CARVIN 12340 World Trade Drive
San Diego, CA 92128
(858) 487-1600
FAX 487-6629

Table with assembly and revision information:
DRAWN BY: GEORGE DREYER DATE: 26SEPT05
APPROVED: DATE:
PCB NO: 30-42120 REV: C
ASSY NO: 80-42120 REV: C
REVISED BY: GEORGE DREYER DATE: 14JULY06

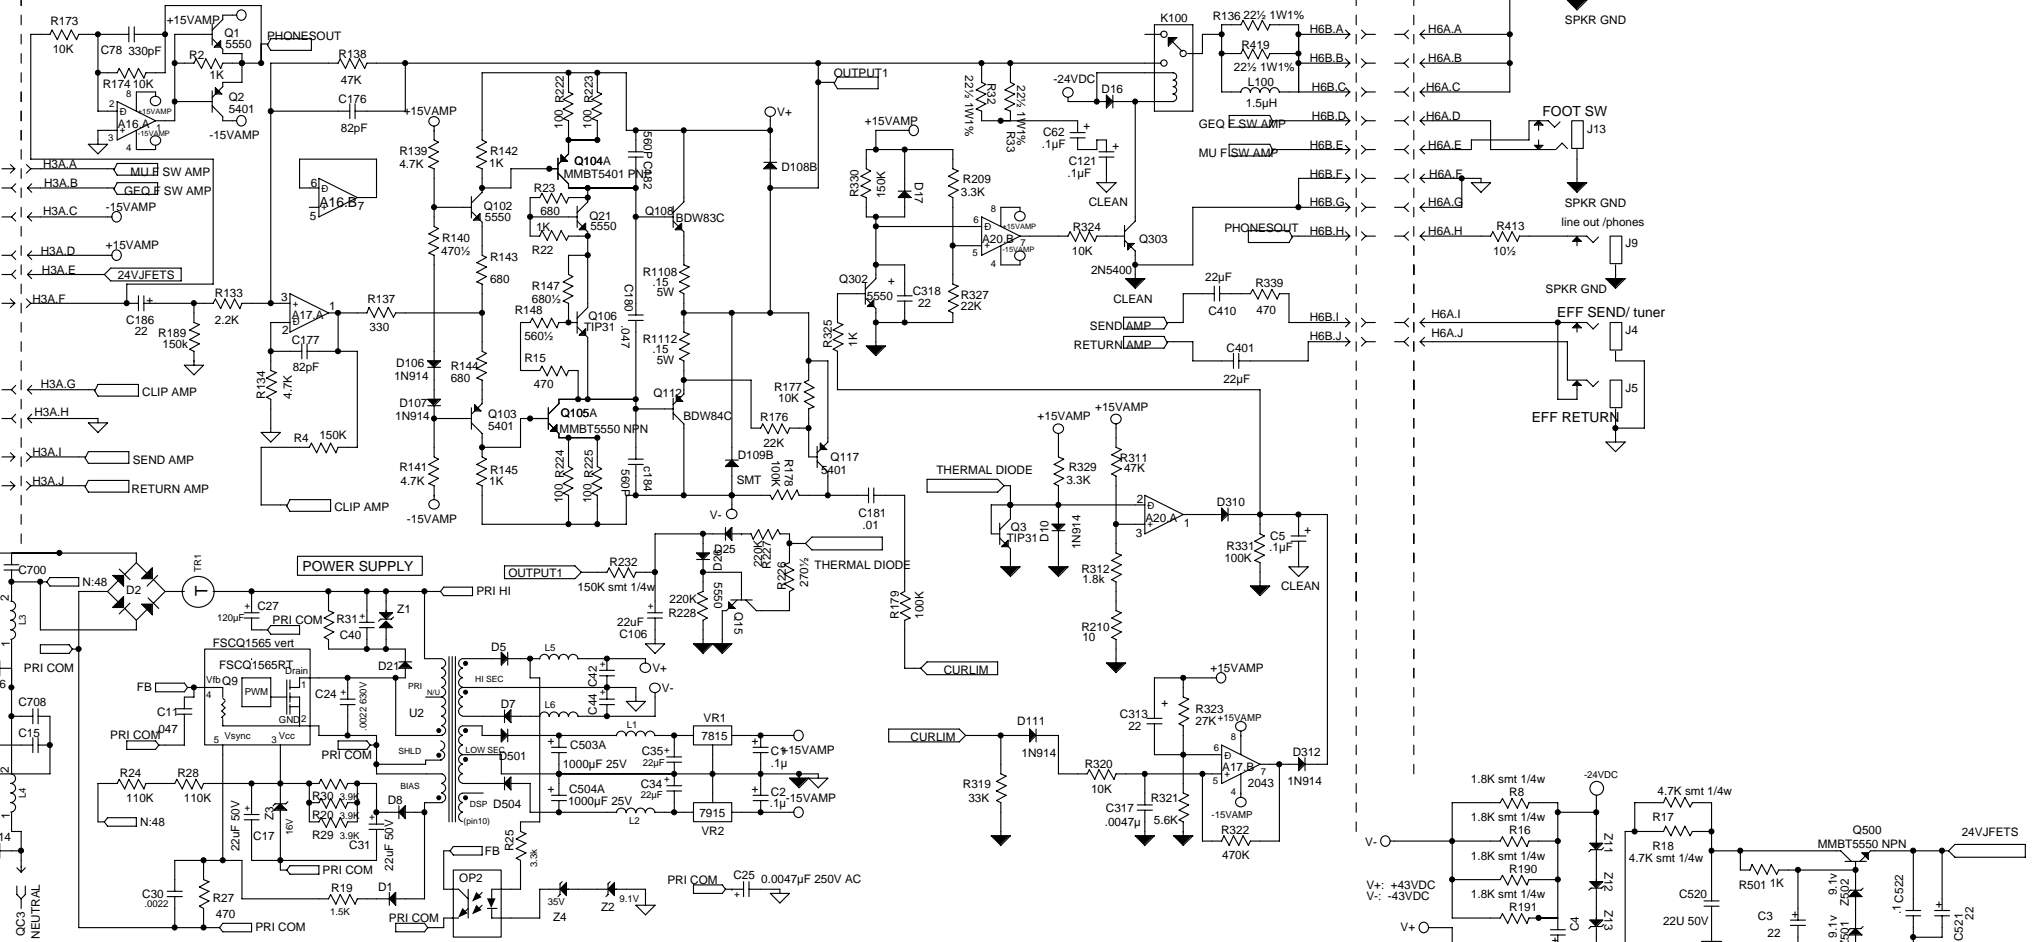
Changes from Assembly Rev (A).
Proto corrections: -15V via grounded, R257 grounded, Locational errors D11 moved up; added R11.
